Accessibility Survey

City of Downey Devenir Avenue - Paramount Boulevard To Downey Avenue

Date of Inspection
12/29/2016

Disability Access Consultants

Sidewalk East Of Brock Avenue @ 33.918621767614, -118.152047395706

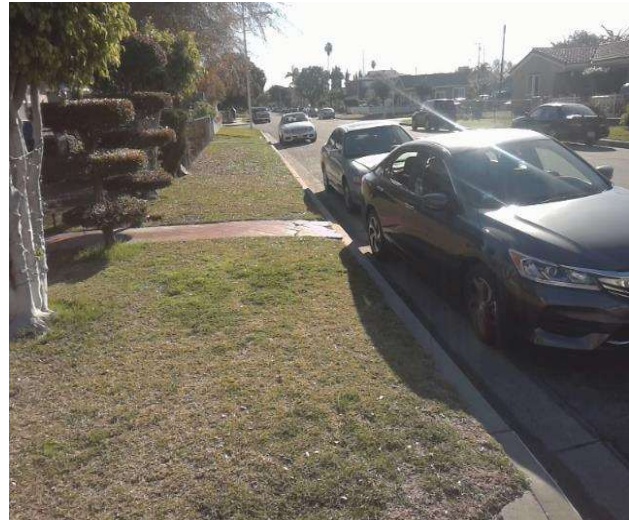
Sidewalks : Missing Sidewalk

Section of sidewalk is missing and consists of dirt, grass or gravel.

On-Site Finding 96.00 feet

Provide a compliant sidewalk for the missing section.

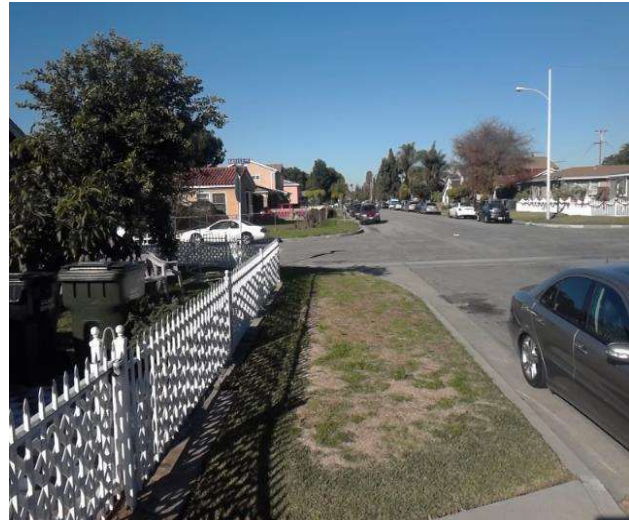
Section of sidewalk is missing and consists of dirt, grass or gravel.

On-Site Finding 35.00 feet

Provide a compliant sidewalk for the missing section.
